Proposed Law Park Design

Lake Monona Waterfront
Design Challenge
City Technical Team
Review Comments

Proposed Law Park Design (cont.)

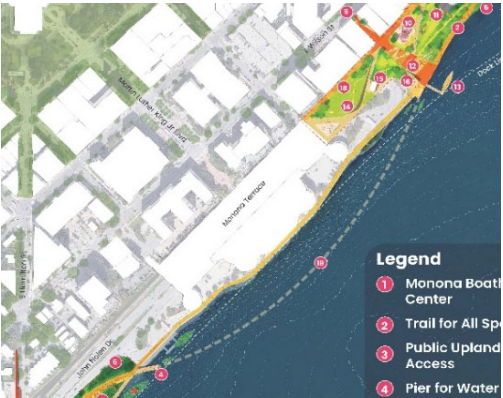
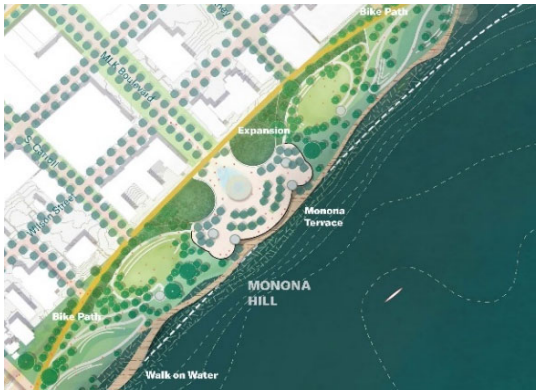
The proposed roadway design in Law Park, north of the Monona Terrace, omits access to the Machinery Row parking lot. The private lot is the off-street parking and delivery location for Machinery Row businesses.	The proposed beach near the Broom Street intersection is along a historically-filled shoreline and the lake bottom drops steeply. This condition requires non-swimmers to stay close to shore.	The proposed pedestrian overpass at the Broom Street intersection will likely obstruct views of the Capitol from the lake shore. It will also provide a jump platform into the lake.
The proposed King Street extension requires removal and redevelopment of three privately-owned properties (155, 307, and 327 E. Wilson Street).	The proposed King Street extension requires removal and redevelopment of three privately-owned properties (155, 307, and 327 E. Wilson Street).	The proposed decking over John Nolen Drive north of the Monona Terrace will obstruct two floors of existing condominium units at 155 E. Wilson Street.

The King and Hamilton Street pedestrian overpass structures may create jump platforms into the lake.	It appears the proposed development of Law Park north of the Monona Terrace does not include an access ramp for emergency boat services (identified in the Preliminary Report).	The route of the multi-use path south of the Monona Terrace isn't clearly defined.
The proposed Monona Hill appears to show that people on bikes would need to ride up it to stay on the path. Many people on bikes will not want to ride up the path and will instead use the boardwalk unless they are heading to MLK (which seems like it will connect). Recreational riders will likely want to stay along the water especially visitors.	The proposed decking over John Nolen Drive north of the Monona Terrace will obstruct two floors of existing condominium units at 155 E. Wilson Street.	It is not clear if the Visitor Center & Entry Plaza bridge is high enough to clear the railway line. It also appears to have a large stair with no accessible route.

The proposed beach at King Street conflicts with an existing fishery habitat (identified in the Preliminary report. The design and extent of the beach area must avoid disturbing this sensitive environmental system.	The proposed beach north of the Monona Terrace conflicts with an existing fishery habitat (identified in the Preliminary report. The design and extent of the beach area must avoid disturbing this sensitive environmental system.
Some of the graphics seem to show that people will both walk and bike on separate paths on Monona Hill & the waterfront area is for "strolling" so not sure what that means for usage. There does seem to be a lowered path as well in a graphic but not sure how that would work. Is it in the tunnel? What would that be like - motor vehicle fumes might be a real concern.	Removing John Nolen Drive vehicle lanes north of the Monona Terrace will cause significant disruption to traffic flow, given current traffic volumes.	The elevated waterfront park concept is interesting but wonder how this would work from a walking/biking perspective as well as accessibility.

The plan does not provide the pork chop island at Williamson St. A previous study explored omitting the island, and there were problems with not being able to separate the pedestrian walk indication from the right turn signal. The King Street pier structure may create a jump platform into the lake.	The Overlook at Hamilton street could become a jumping platform into the lake.

Agency Landscape + Planning	James Corner Field Operations
Will there be an easy way for people on bikes to reach the overlooks and sitting space without creating additional conflicts? Will there be space for people to park their bikes to enjoy those amenities or would then need to park at either end of the causeway to do that?	Broom St cul de sac - need to ensure that the path crossing is well designed so that people driving in to pickup or drop-off (especially people from out of town) are yielding and driving safely.
Will need to ensure the overpasses work for flow both on/off and through the area as the transitions can be tricky. The graphic shows lots of different potential movements that would need to be well thought out to minimize conflicts between users as someone will be just moving through and others will be just looking around enjoying the views and trying to figure out where they want to go.	Like the idea of improving and separating the fishing area near Lake Monona although this approach may have some challenges and logistical issues It is not clear how the footbridge at Hamilton St is envisioned to work - is there an elevator down? How will it be accessible? How are bikes accommodated? The plan renderings extend beyond the project boundaries, making the available area look larger than it is.

See Monona Terrace comments.	The connection to the proposed King Street pier includes multiple sets of stairs with no clear accessible route. The proposed dog run is on top of Madison Water Utility well #17, which is critical to the city water supply. Well and pump station access must be maintained with any proposed improvements. See Monona Terrace comments.

Proposed Monona Terrace Changes

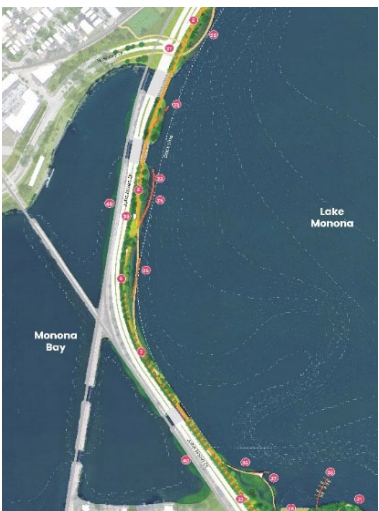
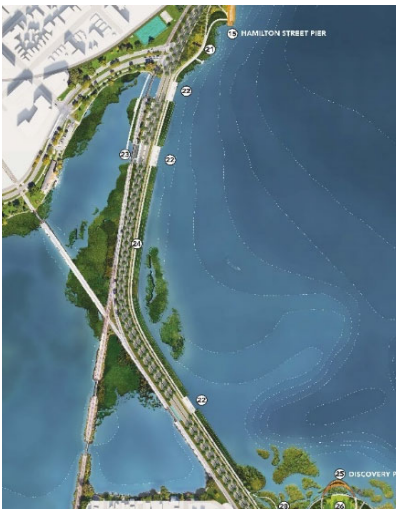
Agency Landscape + Planning	James Corner Field Operations	Sasaki
Any proposed changes to the Monona Terrace are the purview of the Monona Terrace Board and management team. The Monona Terrace is a Frank Lloyd Wright structure, and proposed modifications must maintain this designation. Any changes will likely require review by the Frank Lloyd Wright Foundation in addition to the Terrace Board.	Any proposed changes to the Monona Terrace are the purview of the Monona Terrace Board and management team. The Monona Terrace is a designated Frank Lloyd Wright structure, and proposed modifications must maintain this designation. Any changes will likely require review by the Frank Lloyd Wright Foundation in addition to the Terrace Board.	The proposed master plan works with existing Monona Terrace and accommodates the future expansion zone.
The hill greatly detracts from the signature Monona Terrace and the iconic view ("postcard view" as it is called in the Downtown Plan). It covers too much of the building and seems to visually disconnect it from the Downtown.	It appears the proposed the fishing platform at lake-level extends beyond the State-determined limit for shoreline improvements (Buildable Dockline per the Preliminary Report).

The steepness of the hill will likely make many parts of the area inaccessible. The Bike/pedestrian overpasses down Hamilton/King back up the rear of Monona Terrace are confusing (They seem to go down and then back up to the center of Monona Terrace which would be more easily accessible from MLK Jr. Blvd)	The wall along the bike path helped protect the first floor of the Terrace from flooding in 2018. Pumps and sandbags were placed at the end of the wall to keep flood water from entering the facility. The proposed design removes this feature.	
It appears the proposed multi-use path requires users to climb up to the Monona Terrace elevation and then back down again.

Proposed John Nolen Drive -
Northshore Drive to Lakeside Street
Design

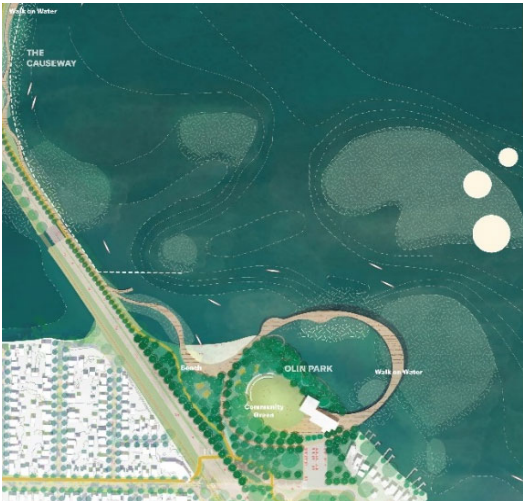
Agency Landscape + Planning	James Corner Field Operations	Sasaki
The proposed master plan works with current plans for the reconstruction of John Nolen Drive and the Blair Street intersection.	The plan does not provide left turn lanes for north-bound John Nolen Drive to Northshore, or north-bound John Nolen Drive to Broom. These are major entrances to downtown and will need some type of accommodation for left turns.	The proposed master plan works with current plans for the reconstruction of John Nolen Drive and the Blair Street intersection.
The narrowed median is consistent with the public feedback received at the 02/23/23 PIM. The proposed master plan appears to work with current plans for the reconstruction of the John Nolen Drive causeway.	The proposed heavy tree planting along the causeway will block the iconic views ("postcard views" as stated in the Downtown Plan) of the capitol and skyline. The anticipated roadway median width is not sufficient to support full-size canopy trees.	The narrowed median is consistent with the public feedback received at the 02/23/23 PIM. The proposed master plan appears to work with current plans for the reconstruction of the John Nolen Drive causeway.

How will the new wetlands/marsh impact the overall walk/bike experience? Will it improve the health of the lake enough that this won't be an area where trash collects and where in the summer the lake has an unpleasant aroma? Want to make sure this is also an enjoyable experience year round.	The narrowed roadway median is consistent with the public feedback received at the 02/23/23 PIM. Note - the narrow roadway media increases the space along the causeway for pedestrians, cyclists, and shore access. However, it does not provide sufficient area for media trees. The proposed row of street trees isn't feasible with the anticipated roadway alignment.	
	How will the new wetlands/marsh impact the overall walk/bike experience? Will it improve the health of the lake enough that this won't be an area where trash collects and where in the summer the lake has an unpleasant aroma? Want to make sure this is also an enjoyable experience year round.

The propose footbridge along the causeway connecting people to Brittingham Park requires further evaluation. The proposed route under the causeway and railroad bridges will be below lake level.
